## **Discussion on “Coupled effective stress analysis of insertion problems in geotechnics with the Particle Finite Element Method” by L. Monforte, M. Arroyo, J.M. Carbonell, and A. Gens**

Jakub Konkol<sup>1,\*</sup>, Lech Bałachowski<sup>2</sup>

### **Abstract**

Fig. D1. PWP distribution around the piezocone: ALE model (frictionless interface) and corresponding SCSEM results. [no colour]

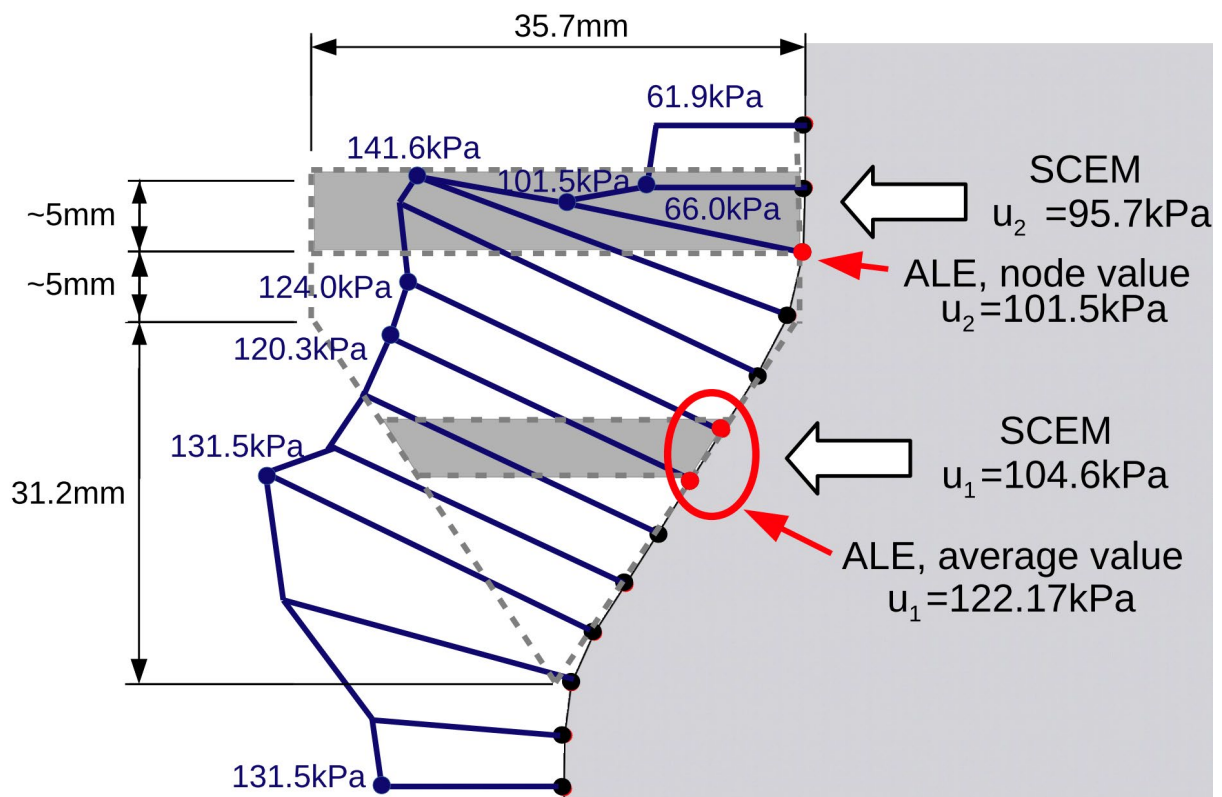
where:  $u$  = pore water pressure around the cone,  $\Delta u_{oct}$  = octahedral component of pore water pressure,  $\Delta u_{shear}$  = shear-induced component of pore water pressure,  $\Delta u_{TSP}$  = total stress path dependent component of pore water pressure,  $s$  = total stress path coefficient ( $s=4/3$  for  $u_1$  and  $s=0$  for  $u_2$  [6]),  $u_0$  = initial pore water pressure,  $K_0$  = earth pressure at rest coefficient,  $\sigma'_{v0}$  = initial effective vertical stress. Using compatible parameters ( $G=877.32\text{kPa}$ ,  $c_u=17.78\text{kPa}$ ) and initial conditions assumed by the Authors (weightless soil,  $p'_0=38.57\text{kPa}$ ,  $K_0=0.5$ ), one can calculate the corresponding components of the mobilized excess pore water pressure:  $\Delta u_{oct}=92.70\text{kPa}$ ,  $\Delta u_{shear}=3.01\text{kPa}$ ,  $\Delta u_{TSP}=8.84\text{kPa}$  (only for  $u_1$ ) and  $u_0=0\text{kPa}$  (due to weightless soil). Consequently, the water pressures at the filter positions are  $u_1=104.55\text{kPa}$  and  $u_2=95.71\text{kPa}$ . With  $G=1306.32\text{kPa}$ , one obtains  $\Delta u_{oct}=101.86\text{kPa}$ ,  $\Delta u_{shear}=3\text{kPa}$ ,  $\Delta u_{TSP}=8.84\text{kPa}$ ,  $u_1=113.71\text{kPa}$  and  $u_2=104.86\text{kPa}$ . These values are significantly lower than those presented by the Authors in Table 4. In Discussers' opinion, this could be attributed to high oscillations and variability of PWP distributions around the cone obtained with LDFEM, such as UL, ALE, MPM or PFEM. Examples of such non-uniform distribution can be seen in the Authors' papers (Fig. 8b in [2], and Fig. 2 in [8]). In Fig. D1, the Discussers present the PWP distributions around the cone from the ALE model (frictionless interface) and the corresponding SCEM solutions for  $u_1$  and  $u_2$ . The concentration of generated PWP is observed at the cone tip and just behind the cone. The Discussers predominantly used the average PWP value from the  $u_1$  area (see Fig. D1). For the  $u_2$  position, the Discussers mainly considered the PWP values close to the actual filter position or the average value from nearby points, see Fig. D1. However, due to high PWP fluctuations in this area, it is difficult to determine the actual  $u_2$  value. This high variability is also observed for field registered  $u_2$  measurements (e.g., Fig. 2 in [9]) or lab tests (e.g., Table 2 in [10]). To sum up, due to uncertainty in determining  $u_2$ , the unique reference SCEM solution may facilitate the

interpretation in the cone vicinity. Discussers would like to ask the Authors for their opinion regarding the reliability of  $u_2$  output in PFEM.

Fig. D2. Effect of interface friction on (a) cone resistance and (b) sleeve friction. [no colour]

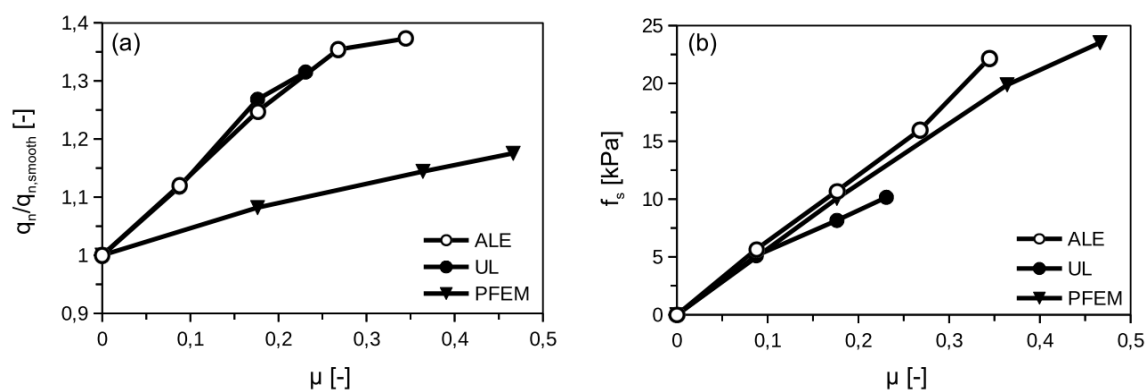
The  $q_n$  increase with interface friction is presented in Fig. D2a. The numerically simulated  $q_n$  obtained using ALE and UL is up to 40% higher than for the corresponding smooth cone and

considerably higher than the PFEM solution. The Authors suggest that PFEM and MPM give similar results when there is an increase in interface friction. They link the discrepancies with the performance of contact algorithm, although both formulations use the contact penalty method. The ALE and UL calculation results presented by the Discussers are closer to the MPM solutions [3] referred by the Authors. This may suggest that the friction component of the cone resistance is underestimated in the PFEM.

Fig. D2b presents sleeve friction increase in relation to interface friction. Here, UL, ALE, and PFEM give almost the same results. However, this to some extent contradicts the cone resistance results (Fig. D2a) and the Discussers would like to ask the Authors for their opinion regarding the contact algorithm performance.

Fig. D3. Effect of interface friction on PWP at (a)  $u_1$ , (b)  $u_2$  and (c)  $u_3$ . [no colour]

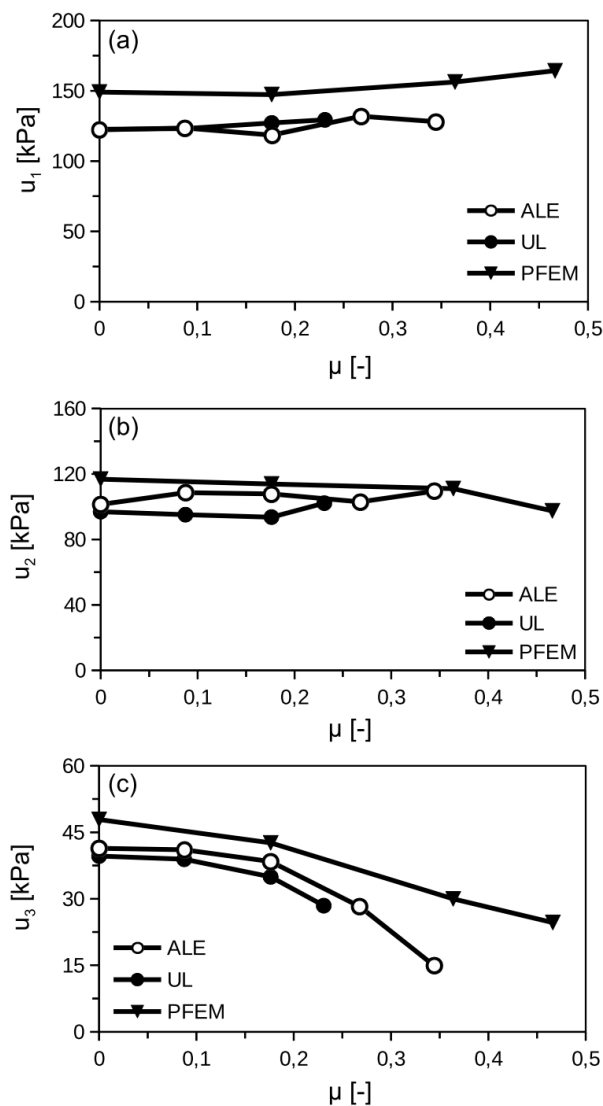
The Authors' analysis of pore water pressures developed around the cone due to different interface friction seems to be incomplete. Of the provided values  $u_1$ ,  $u_2$  and  $u_3$  (in Table 4), only the results of  $u_2$  position are discussed. A comparison between the Authors' and the Discussers' results is presented in Fig. D3. The discrepancies for the  $u_2$  position may be related to the PWP nodes used in the analysis. This issue was already addressed in section 2. The PWP around the cone (in  $u_1$  and  $u_2$ ) seems to be independent of the interface friction. The

research shows that only the  $u_3$  position seems to be slightly influenced by interface friction when  $\mu < 0.2$ . For higher  $\mu$  values, this effect is more important.
